## Review of Kopp *et al.* 'Impact of long-term drainage on summer groundwater flow patterns in the Mer Bleue peatland, Ontario, Canada' submitted to *Hydrology and Earth System Sciences Discussions*.

### Overview and recommendation.

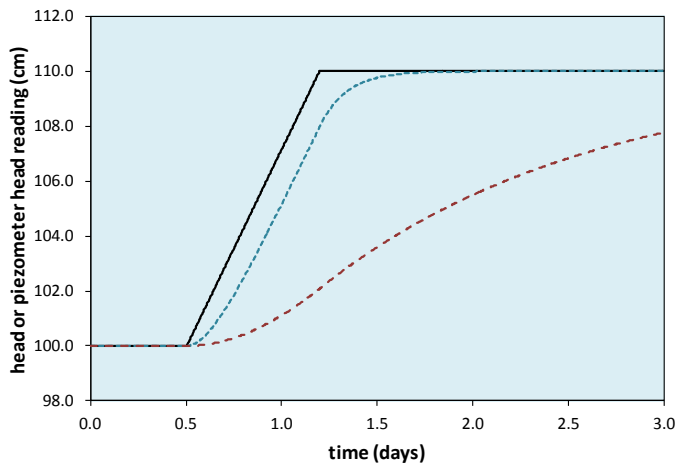
**Page 42, section 3.2.** Some of the  $K$  values are low and may have been caused by smearing of peat around the piezometer intakes, leading to low rates of head recovery during slug tests. Low recovery rates also mean that head readings from some of the piezometers cannot be regarded as reliable. To illustrate this point I modelled a situation where two piezometers of the same design as that in the study were installed in peat. I assumed that one piezometer had an effective  $K$  of  $3 \times 10^{-8} \text{ m s}^{-1}$  and one an effective  $K$  of  $3 \times 10^{-7} \text{ m s}^{-1}$ . By 'effective  $K$ ' I mean the  $K$  of the peat controlling the flow of water into or out of the piezometer. This could mean the smeared peat around a poorly-installed piezometer or just the naturally-low  $K$  around the instrument. I assumed a flow system in which there was no vertical head change and assumed water tables and hence heads at all depths increased by 10 cm over a 17-hour period in response to rainfall, after which they remained stable. I also assumed that, prior to the head increase, both piezometers were in equilibrium with the prevailing head (100 cm). The results are shown below, where the head is shown as a solid black line, the higher- $K$  piezometer by a dashed blue line and the lower- $K$  piezometer by a dashed red-brown line.

From the figure it can be seen that there is an apparent large head difference between the two piezometers, suggesting flow between the higher- $K$  instrument and the lower- $K$  instrument. However, the difference is entirely an artifact of the differential response time. That is why it is important to understand response time when interpreting head data from banks of piezometers. More on this matter can be found in Hanschke and Baird (2001) as previously referenced. The values of  $K$  used here are within the range reported by the authors, so I suspect similar artifacts are present in their data and need to be properly accounted for in a major revision of the paper.
